JV10-NL Block Diagram

Project code: 91.4HX01.001
 PCB P/N : 48.4HX01.0SB
 REVISION : SB

SJV10-NL			
緯創資通		Wistron Corporation 21F, 88, Sec.1, Hsin Tai Wu Rd., Hstchih, Taipei Hsien 221, Taiwan, R.O.C.	
Modify History			
Size A3	Document Number	SJV10-NL	Rev -1
Date:	Sunday, January 31, 2010	Sheet 42	of 42

Title: **RT8223 5V/3D3V**

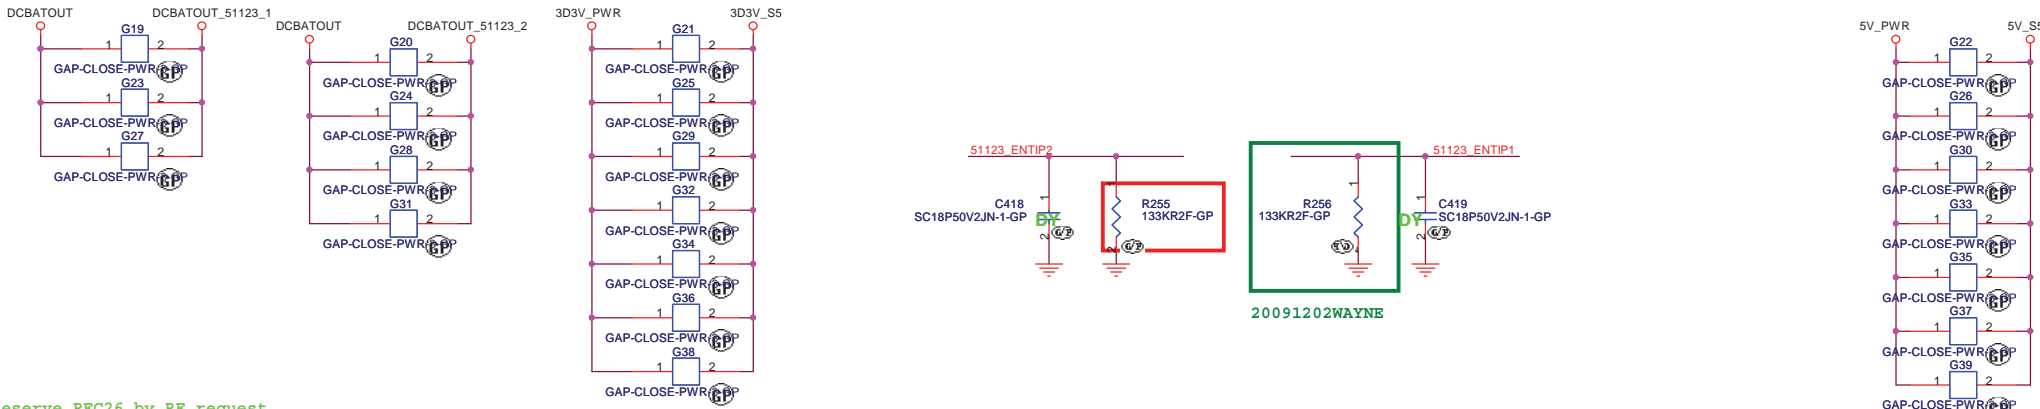
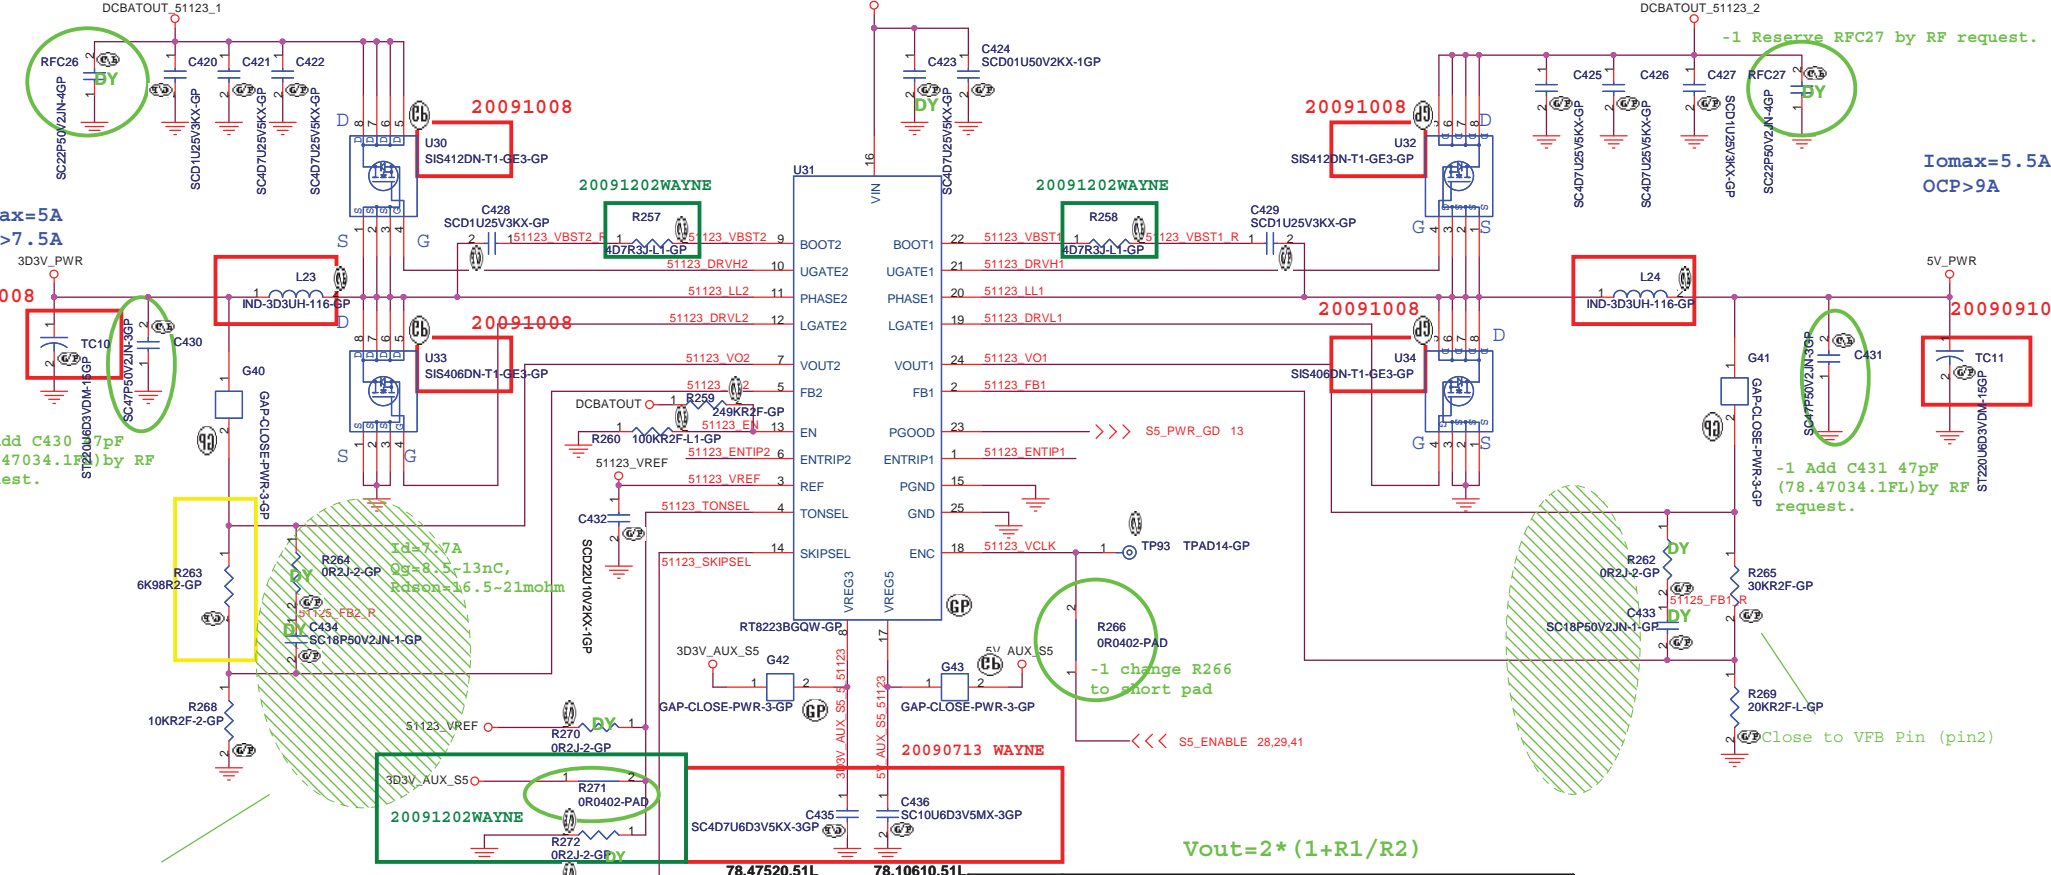
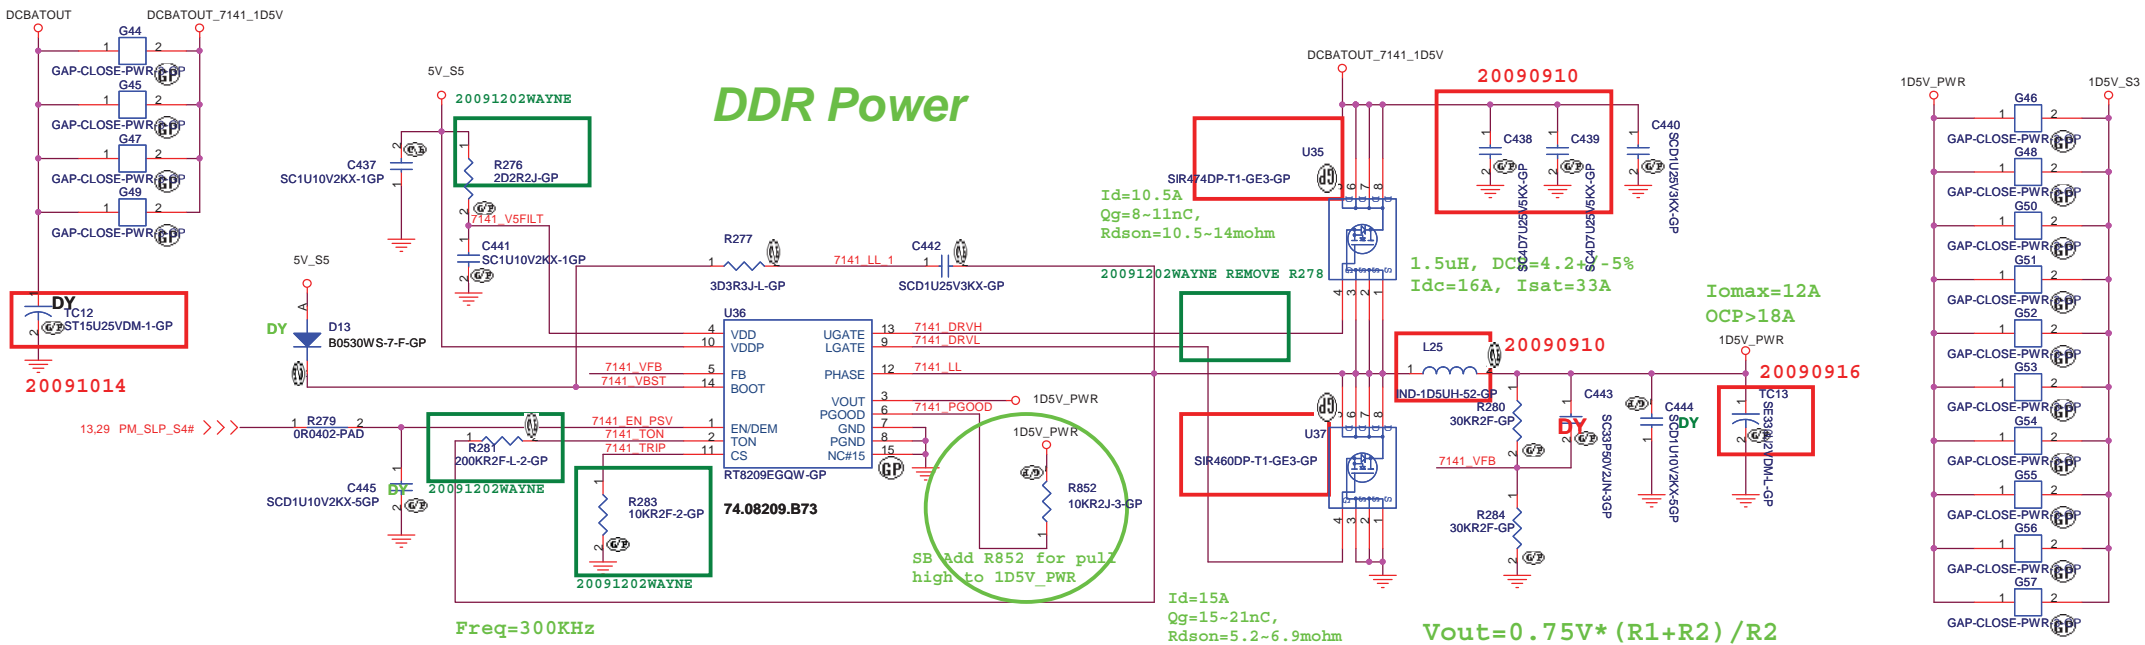
-1 Reserve RFC26 by RF request.

-1 Reserve RFC27 by RF request.

-1 Add C430 7pF
(78.47034.1FL) by RF request.

-1 Add C431 47pF
(78.47034.1FL) by RF request.

-1 change R266 to short pad

-1 change R271, R274 to short pad

-1 Add EC48 47pF
(78.47034.1FL) by RF request.

Wistron Corporation 21F, 88, Sec.1, Hsin Tai Wu Rd., Hsichih, Taipei Hsien 221, Taiwan, R.O.C.	
ISL88731A CHARGER	
Title	Rev
Size	Document Number
SJV10-NL	
Date: Sunday, January 31, 2010	Sheet 38 of 42

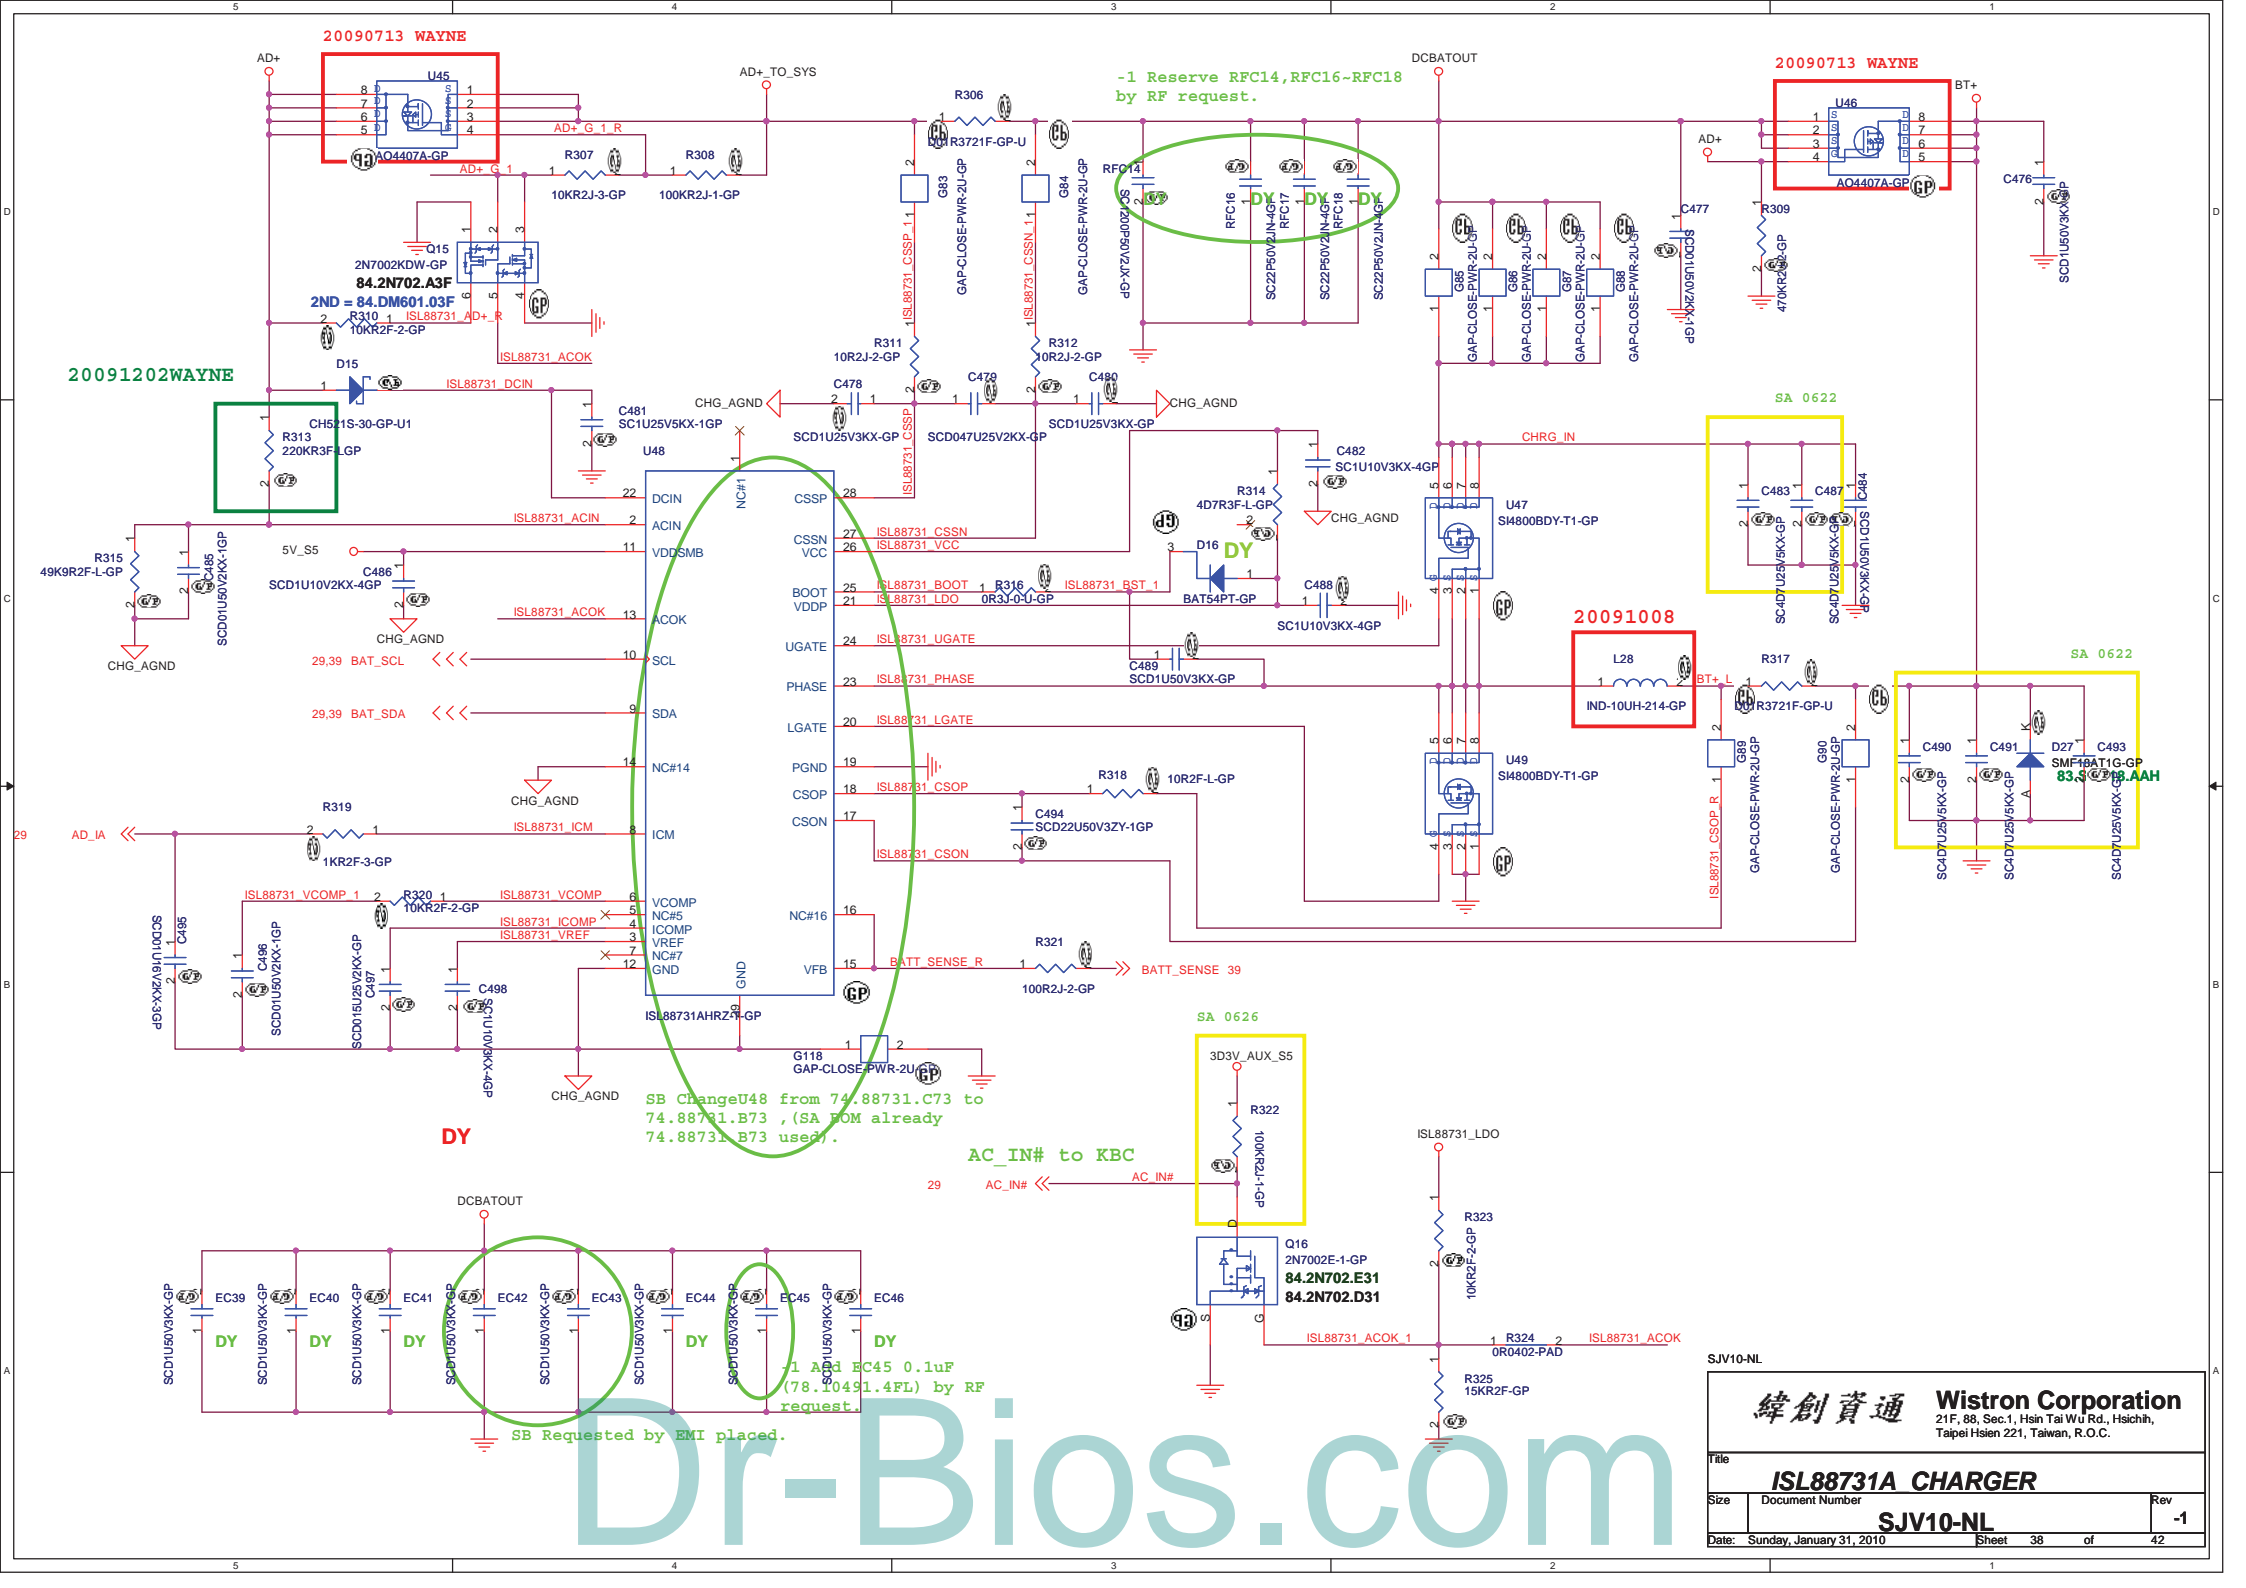
-1 Reserve RFC28~RFC30, RFC37~RFC42, RFC44, RFC45 by RF request.

-1 Reserve RFC14, RFC16-RFC18 by RF request.

SB Change U48 from 74.88731.C73 to 74.88731.B73, (SA POM already 74.88731.B73 use).

Title			AD / BATT CONN		
Size	Document Number				Rev
	SJV10-NL				-1
Date:	Saturday, January 30, 2010		Sheet	39	of 42

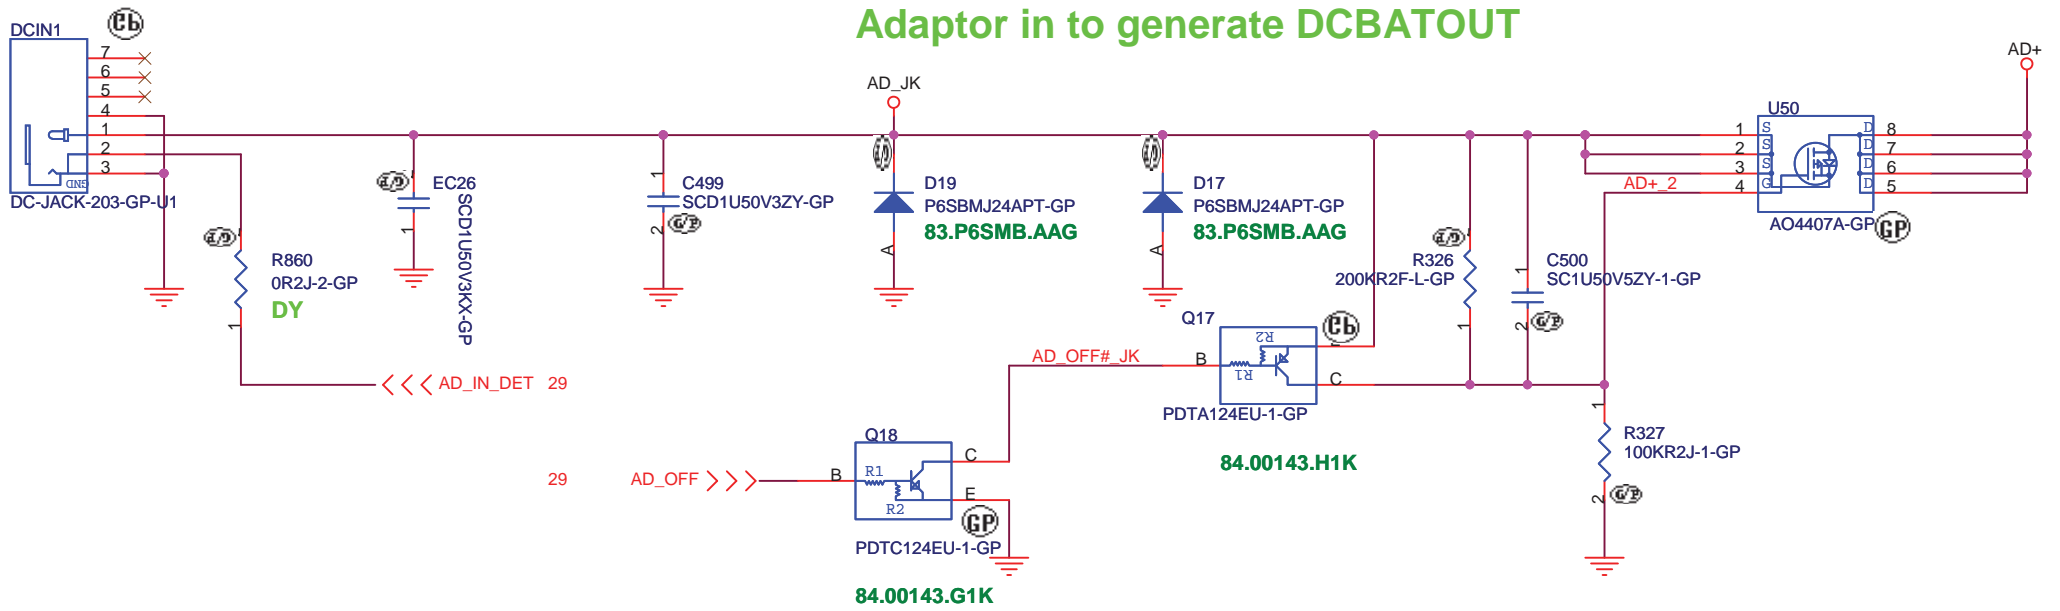
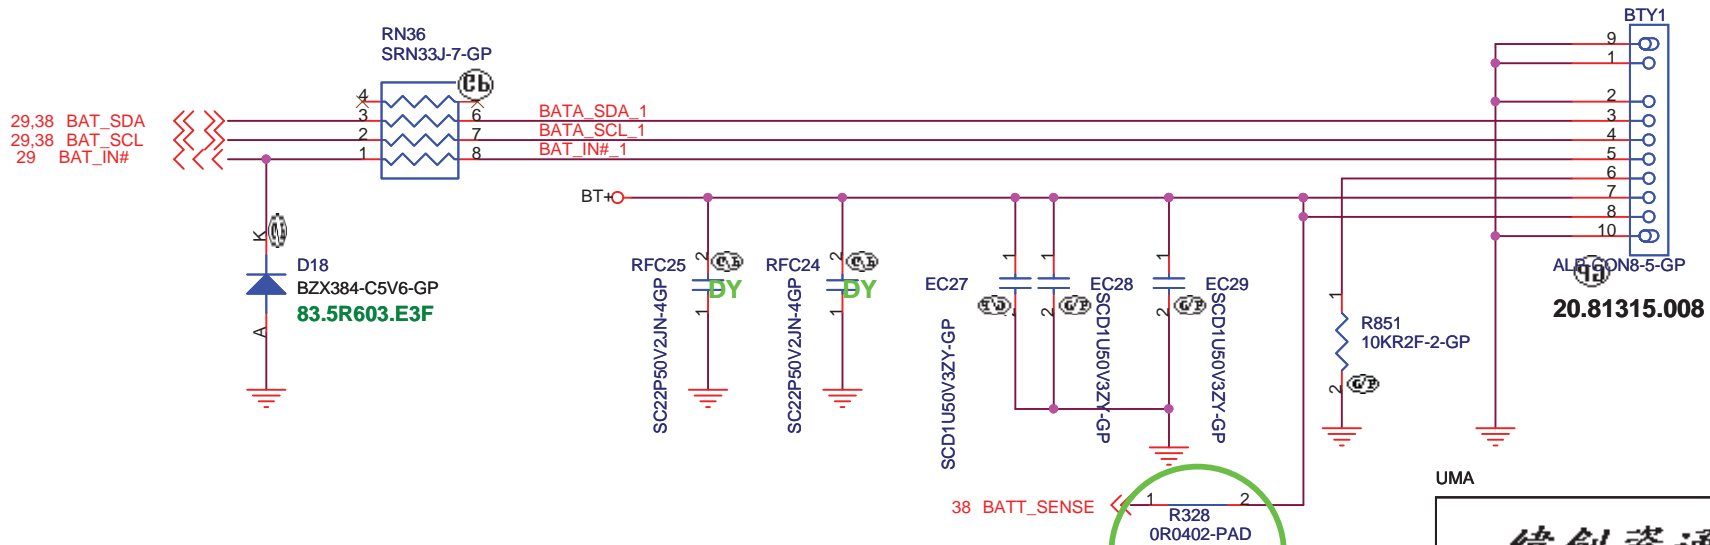
-1 change R328 to short pad
